APPLICATION NO.	FILING DATE	FIRST NAMED INVENTOR	ATTORNEY DOCKET NO.	CONFIRMATION NO.
10/786,534	02/25/2004	Nicolai Tarasinski	09163-US	3254
30689 7590 04/18/2007 DEERE & COMPANY ONE JOHN DEERE PLACE MOLINE, IL 61265			EXAMINER LE, DAVID D	
			ART UNIT 3681	PAPER NUMBER
SHORTENED STATUTORY PERIOD OF RESPONSE		MAIL DATE	DELIVERY MODE	
3 MONTHS		04/18/2007	PAPER

Office Action Summary	Application No. 10/786,534	Applicant(s) TARASINSKI, NICOLAI	
	Examiner David D. Le	Art Unit 3681

DETAILED ACTION

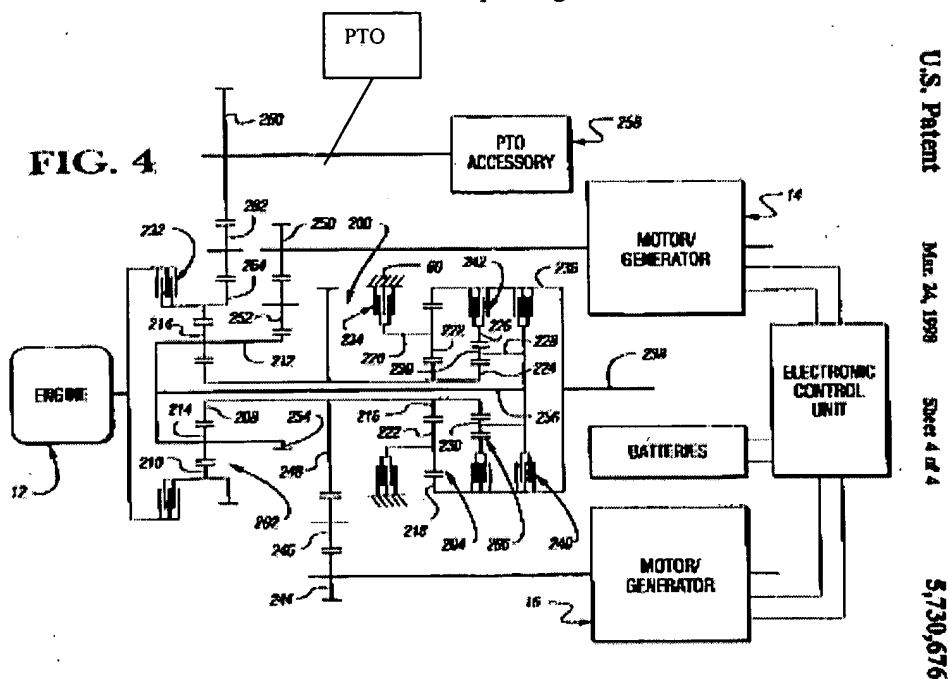
6. **Claims 1, 2, 4, 5 and 9-11 are rejected under 35 U.S.C. 103(a) as being unpatentable over U. S. Patent No. 5,730,676 to Schmidt in view of U. S. Patent No. 6,205,385 to Stelzle et al.**

Schmidt (i.e., Figs. 1-4; column 1, line 30 – column 7, line 54) discloses an electro-mechanical transmission comprising:

- A planetary combination gearbox (i.e., Fig. 4, element 202);
- A first electrical machine (i.e., Fig. 4, element 14);
- A power take-off shaft (i.e., Fig. 4, element PTO as indicated above);
- A gearbox interface (i.e., Fig. 4, element 248) operatively driven by an internal combustion engine (i.e., Fig. 4, element 12);
- A second electrical machine (i.e., Fig. 4, element 16) driven indirectly by the internal combustion engine (12);
- A control arrangement controlling the internal combustion engine, the first electrical machine, the second electrical machine and at least one rectifier (i.e., Fig. 4; column 5, line 29 – column 7, line 54; it should be understood that the

- Wherein the first electrical machine is connected with a second gearbox interface (i.e., Fig. 4, element 212) of the planetary combination gearbox (202), and the power take-off shaft (PTO) is connected with a third gearbox interface (i.e., Fig. 4, element 264) of the planetary combination gearbox (202);

- Wherein the first electrical machine, the second electrical machine and the planetary combination gearbox can be combined to an infinitely variable torque division gearbox for the power take-off (i.e., Fig. 2) and;

Schmidt lacks a brake with which the power take-off shaft can be stopped.
